Final Environmental Impact Statement

KEAHOLE - KAILUA
69 kV TRANSMISSION LINE PROJECT

Hawaii Electric Light Company, Inc.

JANUARY 1994

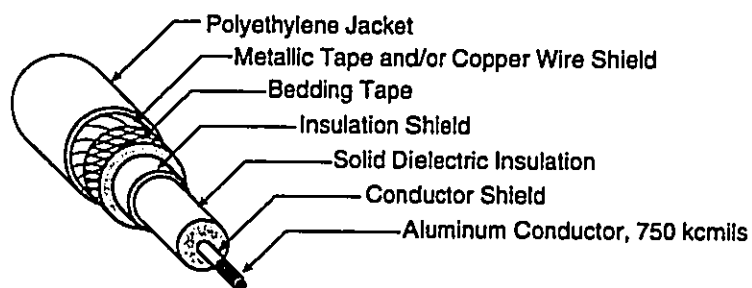
Table 1-1, page 2 of 2, of the E.I.S. shows a 4' x 8' trench. This is inconsistent with the text and Figure 5-8. Is the construction cost of \$1.0 - 3.8 million based upon the incorrect trench size? Also, a cost estimate of whose range is so large needs to be refined.

Figure 5-8 in the DEIS was meant to serve as a schematic "conceptual" diagram of a 69 kV solid dielectric underground cable system, and was not intended to be a detailed engineering construction drawing.

The 4-foot-wide and 8-foot-deep dimensions found in Table 1-1 are correct and are typical for trench excavation work. The trench dimensions are consistent with those in Figure 5-8. A trench must by necessity be larger than what will be installed within it. In this case the trench must be larger than the concrete shell shown in Figure 5-8. This is necessary to allow construction crews adequate access to prepare the bottom of the trench, to shore the sides of the trench, and to lay the concrete forms for the concrete shell, to set the duct lines, and to pour the concrete.
